AGENDA PORTLAND PLANNING BOARD MEETING

To: Brandon Mazer, Chair and Members of the Portland Planning Board
From: Caitlin Cameron, Urban Designer
Date: Friday, April 9, 2021
Re: 200 Federal Street; Level III Site Plan, Subdivision, and Inclusionary Zoning Conditional Use application
Project #: PL-001235-2020
CBL: 032 G001001
Meeting Date: April 13, 2021

1 | SOUTH ELEVATION
1/8" = 1'-0"

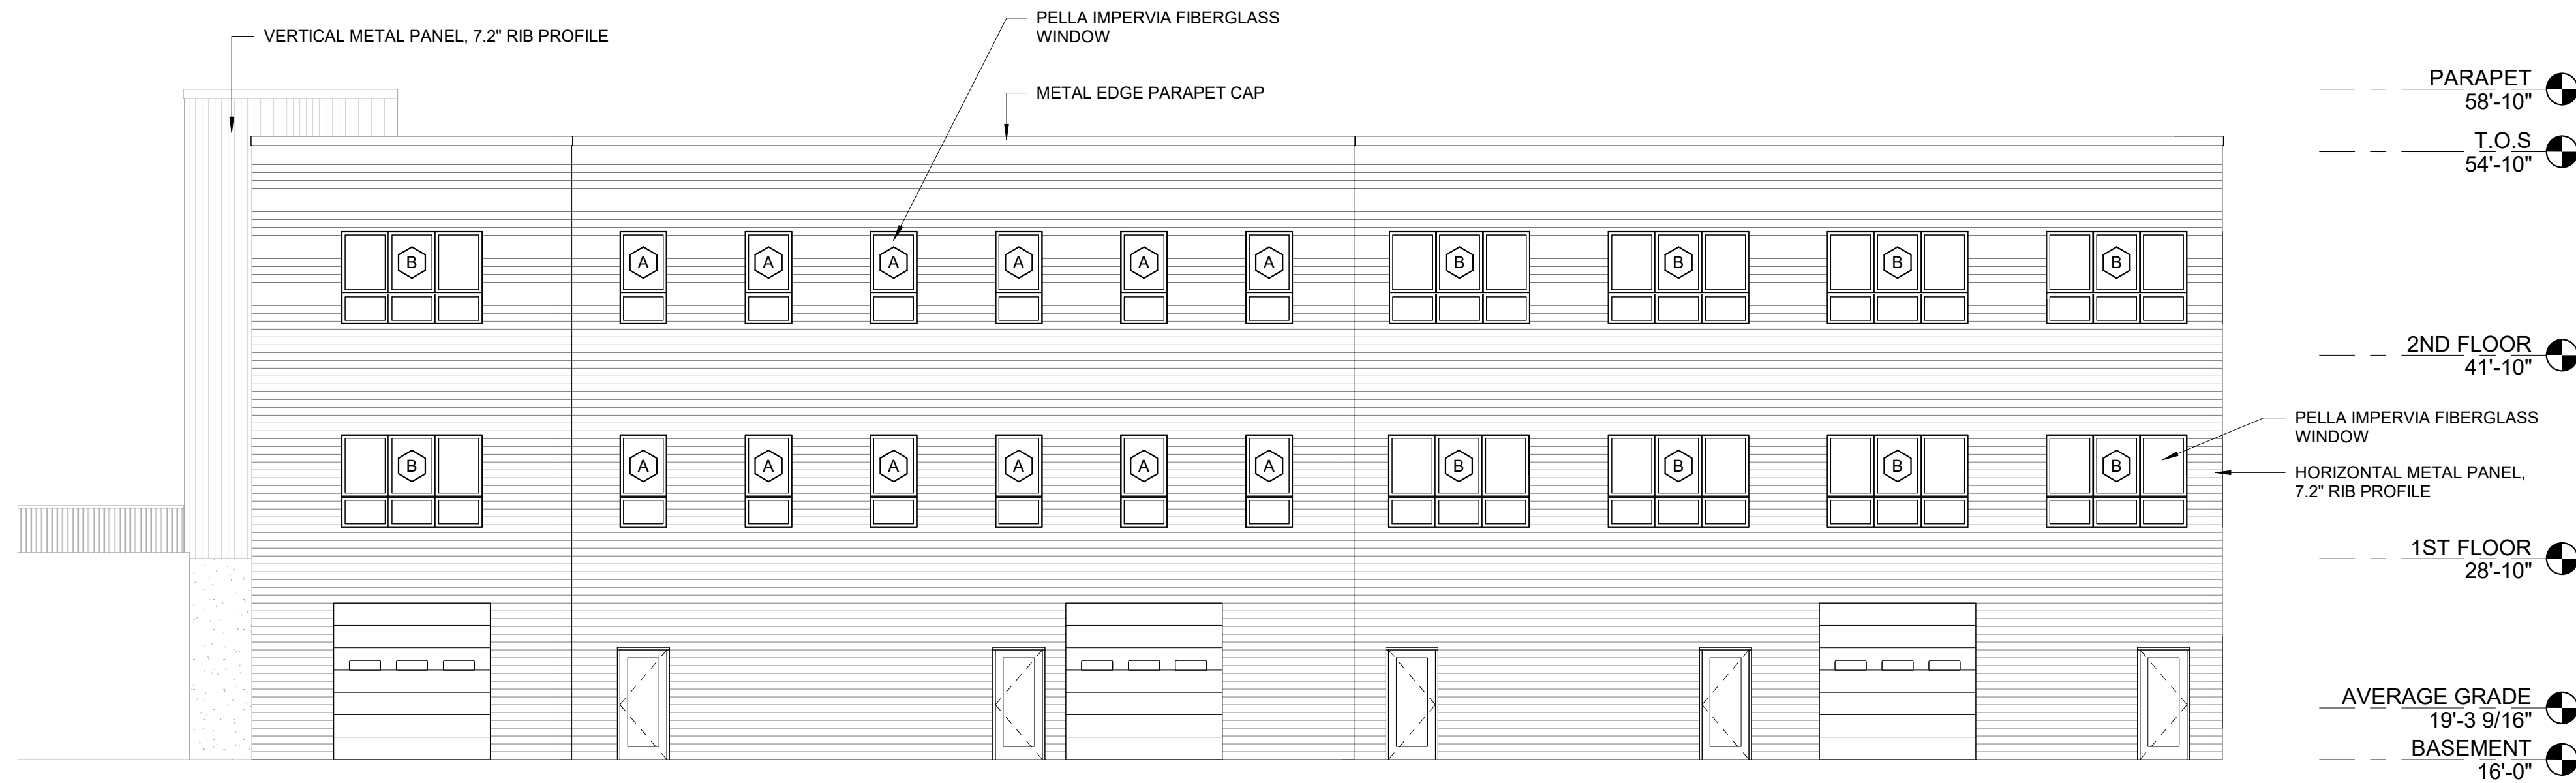
- 3. The average grade of 19.295' provided on Plan A1.00, needs to be shown on the elevation plan, A2.01.*

Response: A revised Plan A2.01 has been prepared and uploaded to ePlan and a copy also accompanies this letter.
